## KENWOOD Service Bulletin

ASB-1035

**Subject:** TS-50S Antenna Lead Wire **Date:** December 7,

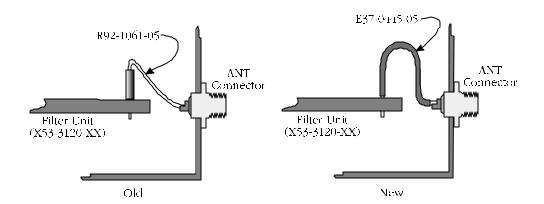
Several users have reported a problem with the antenna lead connection, i.e. the lead that connects the antenna connector to the Filter Unit (X53-3120-XX). Originally this connection was made by a zero ohm resistor. If excessive stress is placed on the antenna connector this lead is easily broken, with a resulting loss of receiver sensitivity and transmitter power. The use of a small flexible jumper wire will increase the flexibility of this connection, thus minimizing the effects of mechanical stress.

Remove the zero ohm resistor and replace it with the small piece of cable. See accompanying diagram.
